Memorandum

To:	City of Greater Geelong	From:	Jason Stone (Traffix Group)
Our Ref:	G36342M-02A	Date:	5 th August 2026

277-279 Scenic Road, Highton Proposed Childcare Centre Development RFI Response

Appendix A – Updated Development Plan

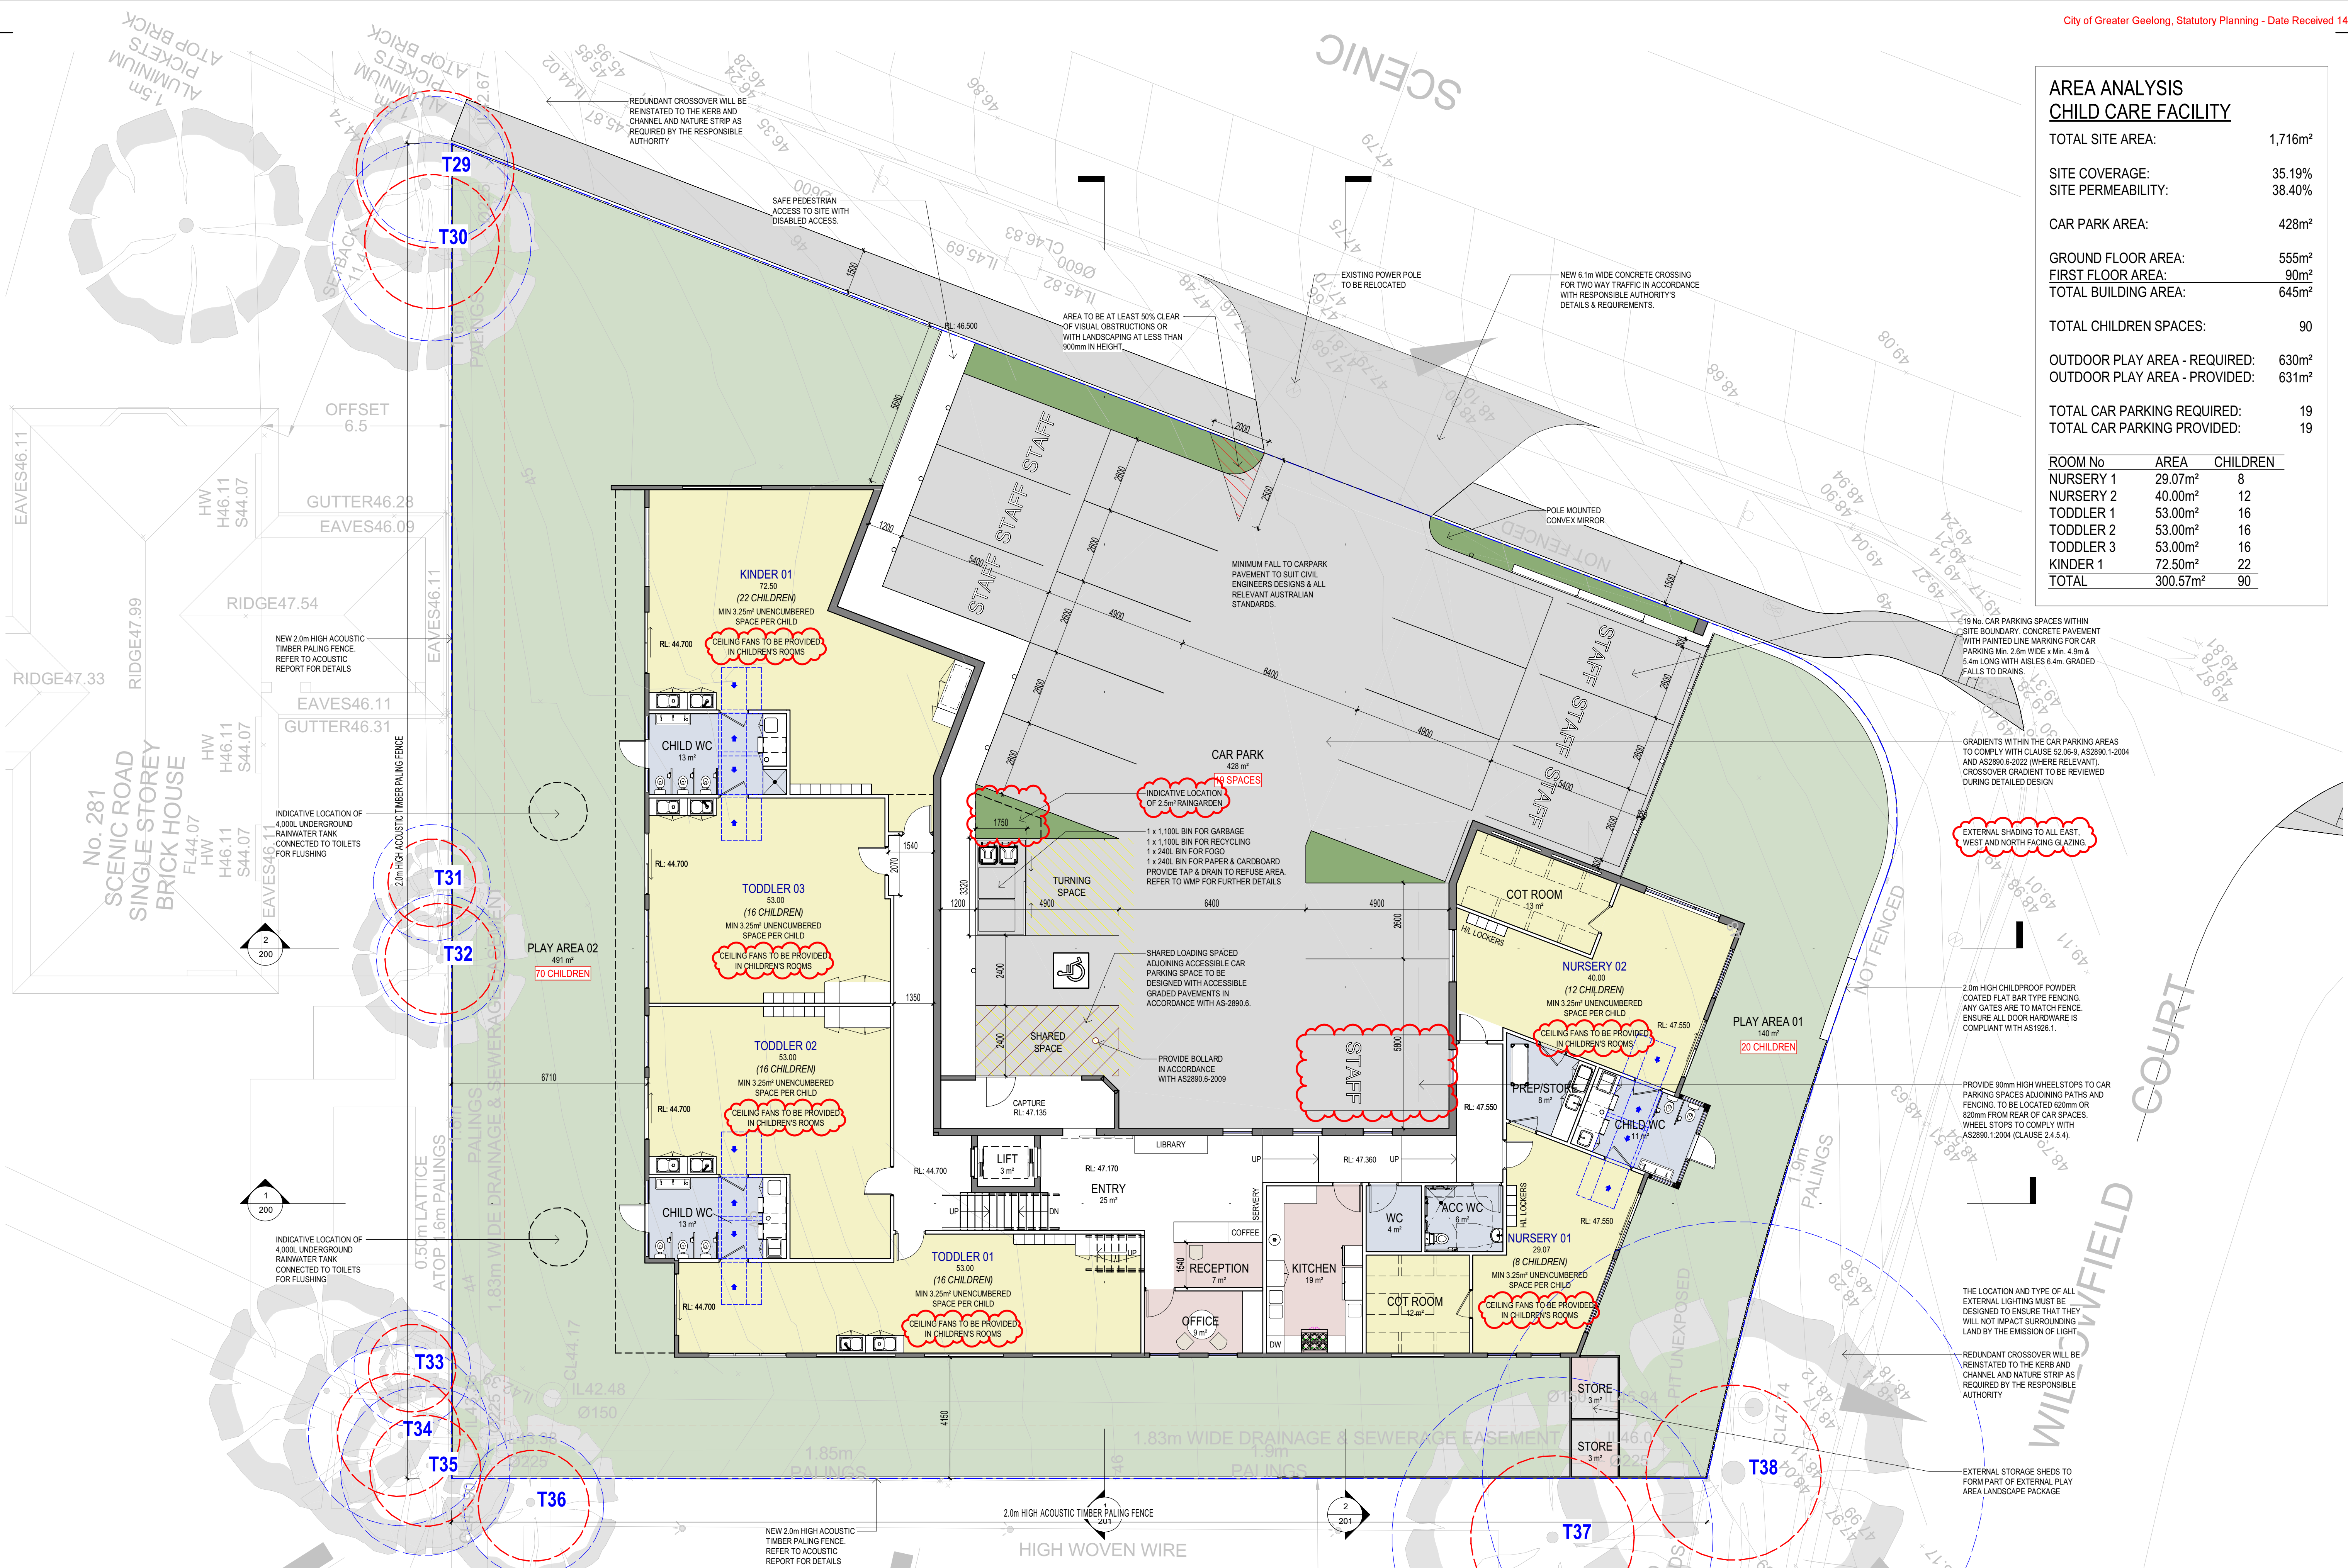
<i>The tandem car spaces must be clearly marked and signed to designate them as 'staff only' spaces.</i>	The rear tandem spaces are labelled as 'STAFF', with front tandem spaces to be available for use by either parents who are undertaking short-term drop-off/pick-up, or by staff. We do not agree that both spaces need to be allocated specifically to staff as this will reduce the effectiveness of the carpark in our experience. Staff who park in the rear are typically staff who arrive to the site first with longer shifts. If staff park them in, they will co-ordinate this as required. If parents park in the front space, it is expected that this would only occur momentarily during drop-off and pick-up periods and there may be a momentary wait, should that staff member wish to leave at that exact moment. This is unlikely to occur with any frequency, and the CPMP outlined below can provide instructions to parents and staff.

Appendix B – Civil Plan

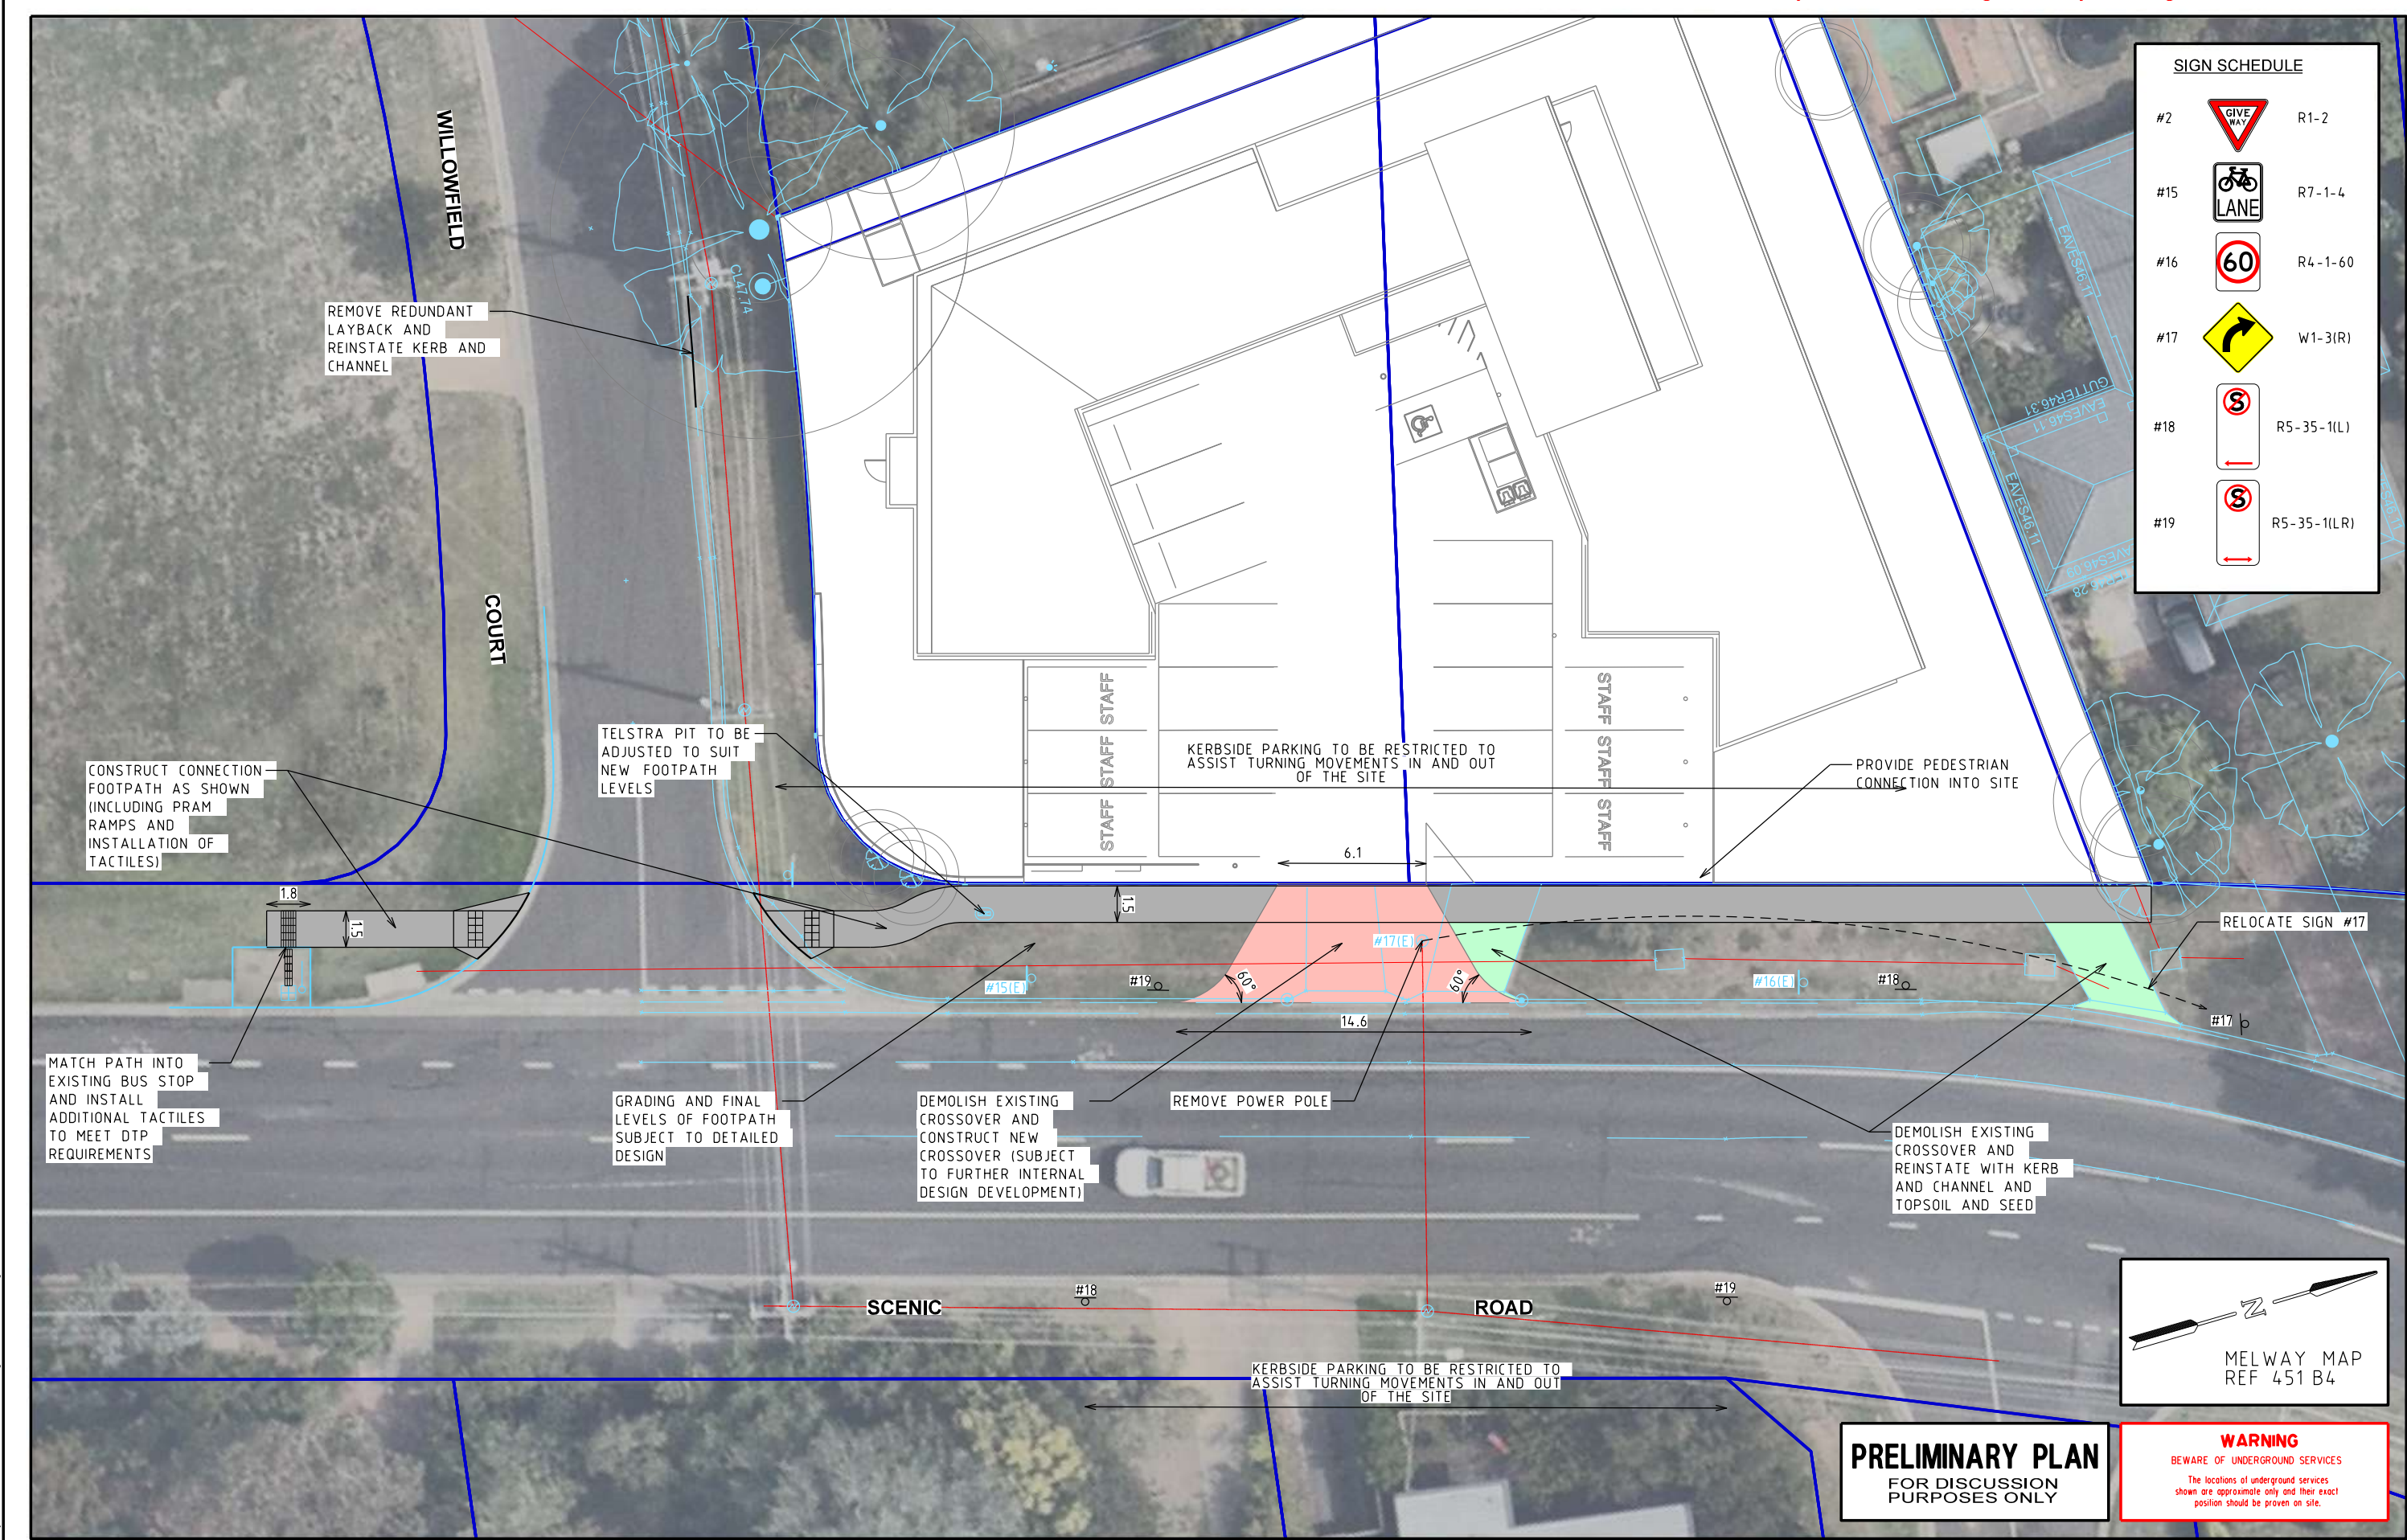
RFI Item	Response
<i>Existing and design levels must be provided in Scenic Rd and the car park, and preferably with a Contour Plan.</i> <i>No design levels have been provided so it is not clear if the level at the road reserve boundary at the entrance will match that of the car park. The site will have to be filled otherwise the grades of the car park will be excessive. The car park itself will have to be shaped so that all runoff drains away from the building.</i>	A civil plan has been prepared by TMCOT Pty Ltd and is attached at Appendix B. This plan includes design levels for the vehicle crossover, new footpath and the on-site carpark. We are satisfied that the civil levels proposed are acceptable in relation to traffic engineering matters and that the crossover and carpark will operate to a high standard. We note DTP was comfortable with the proposal as per its referral letter dated 22nd July 2026.

<i>The verge in Scenic Rd has reverse fall (i.e. the levels at the road reserve boundary are below that of the Top of Kerb levels). The longitudinal grade of the proposed vehicle crossing cannot be any steeper than the existing vehicle crossings, and the levels at the road reserve boundary cannot be changed.</i>	The architectural drawings have been updated to include the civil levels. We understand that the proposed vehicle crossover is marginally less steep than the existing crossovers in order to accommodate the accessway and proposed footpath. There are very minor adjustments to the levels at the vehicle crossing location in order to accommodate this and we consider that this is reasonable. It is not uncommon for minor variations to existing levels to occur when resolving detailed design matters.
<i>While it is appreciated that the developer wishes to construct a new concrete footpath outside of the subject site and up to the bus stop pad, the levels and crossfall of the existing verge will make this challenging to design. Please</i>	The provision of a footpath was suggested by DTP during the pre-application discussions and formed part of the Concept Plan agreed to by DTP.

RFI Item	Response
<i>provide further investigation and justification if DDA compliant grades can be achieved.</i>	The civil drawing which has been prepared outlines that the crossfall of the proposed footpath is 1:40, which is acceptable. Given the natural fall of the land along Scenic Road, it is not possible to provide for a DDA compliant footpath in the north-south direction. We consider that this is still acceptable, as it still provides infrastructure where there currently is none. For example, the existing bus stop south of the site has no footpath to access it, only a grass verge (of the same gradients proposed for the footpath) with inadequate pram crossings to cross Willowfield Court. The plans improve on this situation with new and improved pram crossings, with footpath connection to and from the bus stop and along the site frontage to Scenic Road. There are numerous instances of footpaths across Victoria which are steeper than DDA standards in the direction of travel due to steep topography and this is acceptable in practice.
